Re: *Work Plan Modification and Approval (Revised May 29, 2008)*
Pan American Tannery Remedial Investigation (ERP Site No. B00175)
City of Gloversville, Fulton County, New York
C.T. Male Project No. 04.9109

The RI Work Plan dated October 26, 2005 is hereby modified as explained in the following paragraphs:

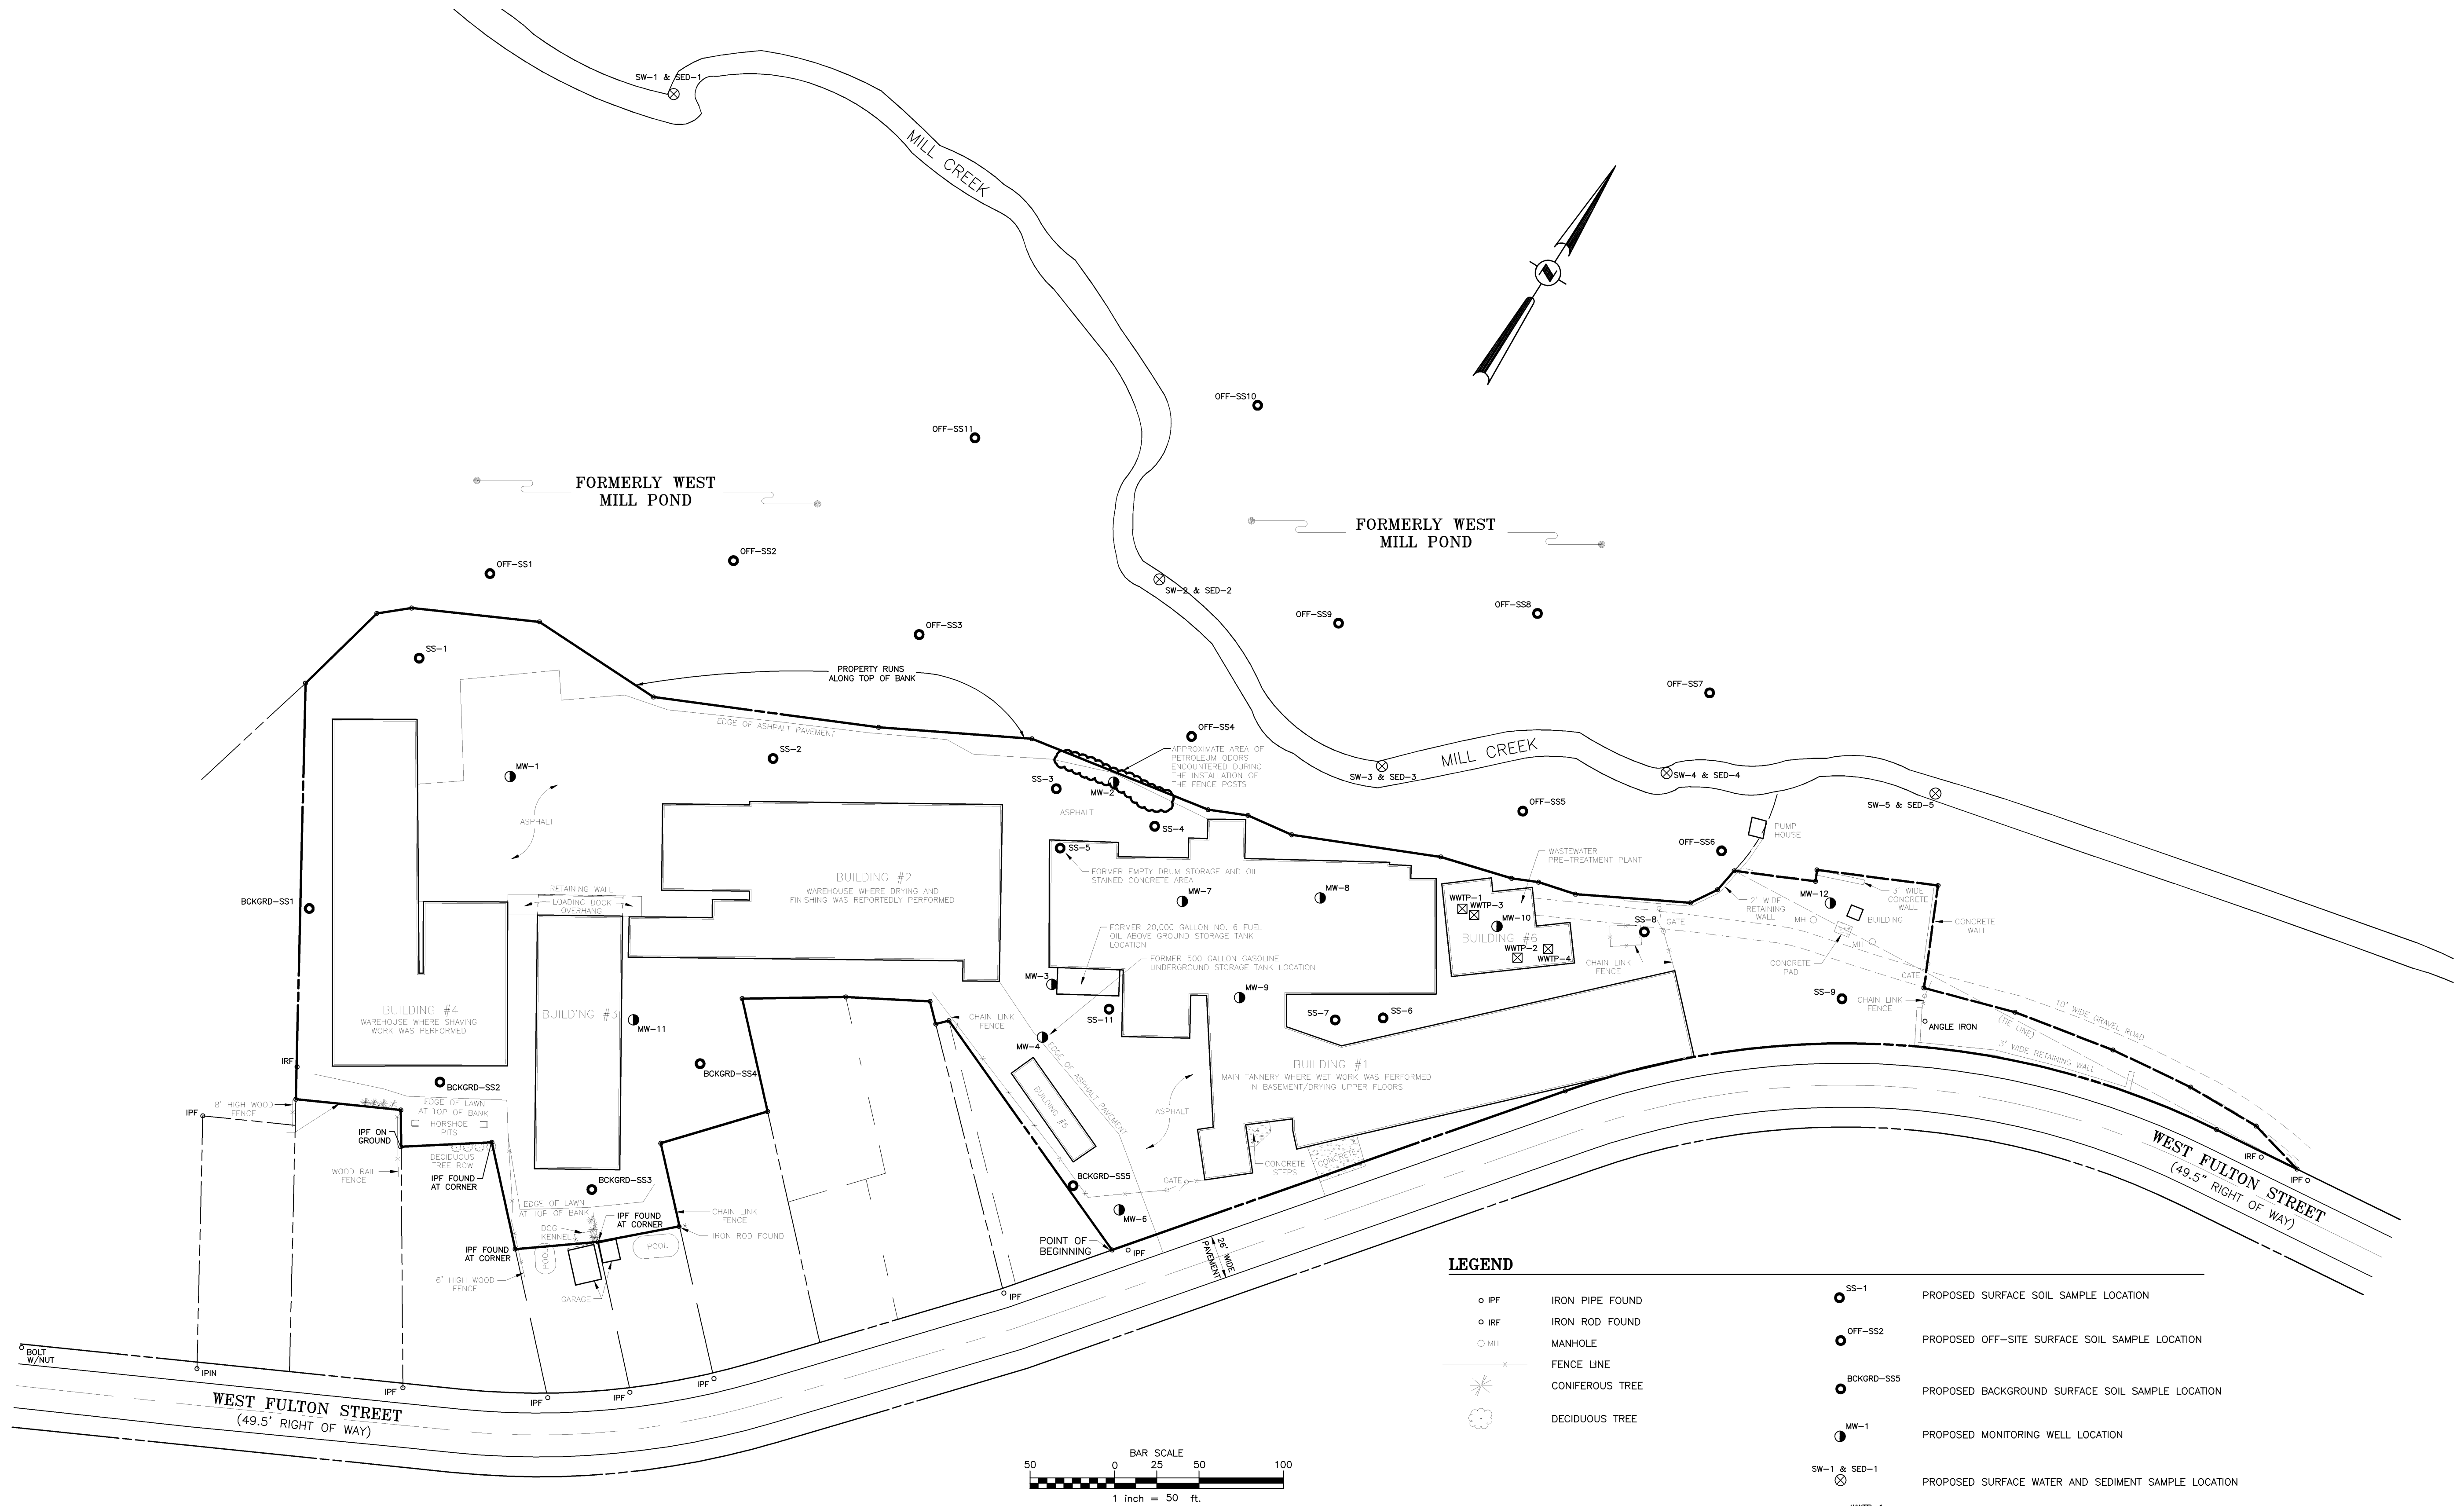
The RI Work Plan is hereby modified to include further evaluation of the potential for impacts to soil in the localized area where the stained concrete was removed. This will be accomplished by performing a visual assessment using hand digging and soil screening with a photo-ionization detector to determine the extent of oil stained soil. Based on the findings of the visual assessment, one soil sample will be collected and analyzed from the area of highest subjective evidence of impacts, if any, and analyzed for the surface soil sampling parameters. This will be accomplished by relocating surface soil sample SS-5 to this area, as shown on the revised Figure 9, Proposed Sampling Locations within the work plan.

Although there was no evidence of staining observed on the ground surface around the empty transformer, it remains unclear whether or not the transformer oil was properly drained or discharged/leaked where the transformer was staged or formerly located. Therefore, the RI Work Plan is hereby modified to relocate surface soil sample SS-11 to the area where this transformer was formerly staged, as shown on the revised Figure 9, Proposed Sampling Locations within the work plan. Field measurements of the former location of the transformer in question were collected and are maintained in our files for locating the sample. Proposed soil samples SS-6 and SS-7 will remain and will assess the potential for impacts where the transformers were assumed to be mounted.

As part of the Building Demolition and Asbestos Abatement work, a chain link fence was installed around the perimeter of the work area. During the drilling for the fence posts on November 6, 2007 Bianchi Industrial Services, LLC reported to C.T. Male that petroleum odors were observed on the soil cuttings in more than one drilled hole, northwest of Building #1. C.T. Male required Bianchi to notify NYSDEC of the petroleum finding and Spill No. 0751076 was assigned. The drilling cuttings with petroleum odor were placed in two 55-gallon steel drums for characterization and disposal. The drums were staged in one of the buildings and will remain on-site and characterized/disposed together with the investigation derived waste generated during the RI. The approximate area of petroleum odors in soil is shown on the revised Figure 9, Proposed Sampling Locations within the work plan.

- Surface soil samples SS-3 and SS-4 was moved to the area near where the petroleum odors were observed to determine the potential horizontal extent. The revised locations are shown on the revised Figure 9, Proposed Sampling Locations.
- Surface soil sample SS-2 was moved easterly to fill in the potential data gap left by relocating surface soil samples SS-3 and SS-4.
- Monitoring well MW-2 was moved to the area where the petroleum odors were observed, and centrally located to evaluate the potential groundwater impacts from these findings.

The revised locations are shown on the revised Figure 9, Proposed Sampling Locations within the work plan.
